San Luis Obispo Regional Transit Authority  
Bus Maintenance Facility  
03/31/20

**SLO RTA BUS MAINTENANCE FACILITY  
SAN LUIS OBISPO, CA**

**Bid Addendum No.2  
March 31, 2020**

E-101

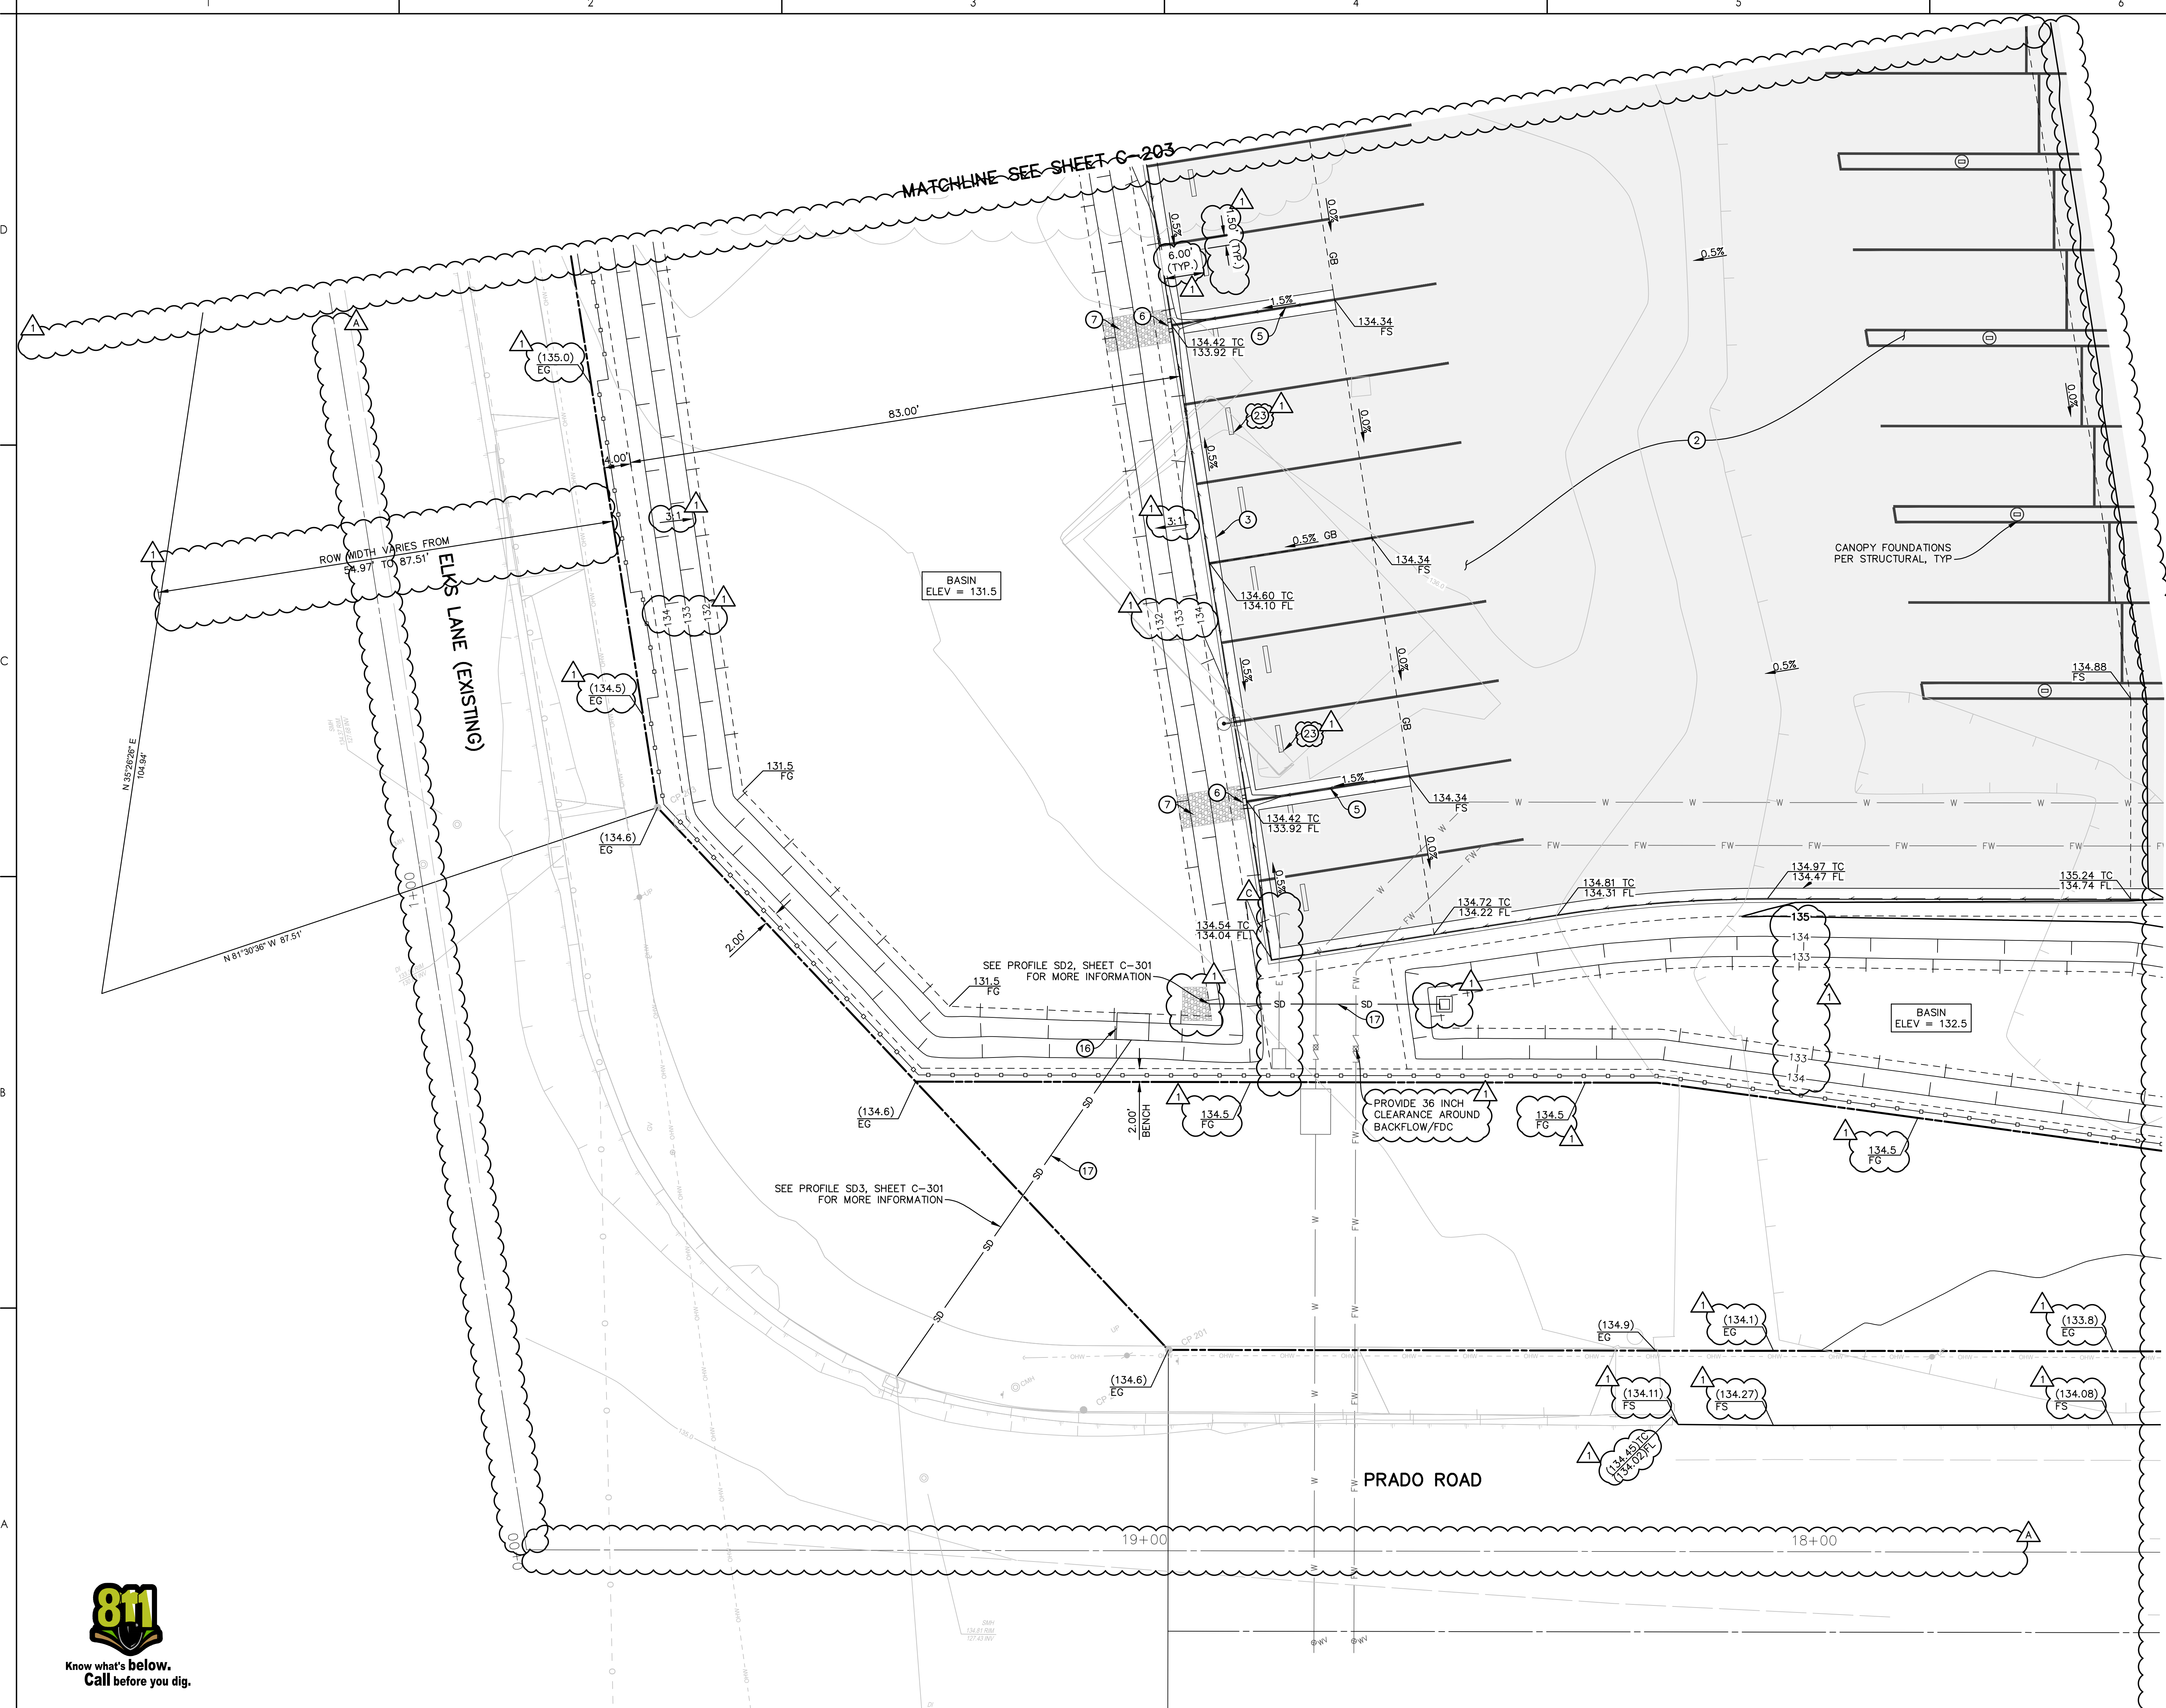
*Following the Issue For Bid documents, the design team received engineering feedback from PG&E for the electrical primary service for the proposed facility. Drawings E-100, E-101, C-205, C-206, C-300, and C-302 have been revised to reflect these changes in coordination with PG&E. The future primary service connection, conduits and pull-boxes, for a second primary service to the bus canopy area has been removed from the current primary connection off of the south/east corner of the project site. New conduits and pull-boxes have been added for future primary connections from both Prado Road at the southwest corner of the site and from Elks Lane adjacent to the bus exit driveway.*

- a. Please Replace Sheet E-100 with E-100\_addendum2
- b. Please Replace Sheet E-101 with E-101\_addendum2
- c. Please Replace sheet C-205 with C-205\_addendum2
- d. Please Replace Sheet C-206 with C-206\_addendum2
- e. Please Replace Sheet C-300 with C-300\_addendum2
- f. Please Replace Sheet C-302 with C-302\_addendum2
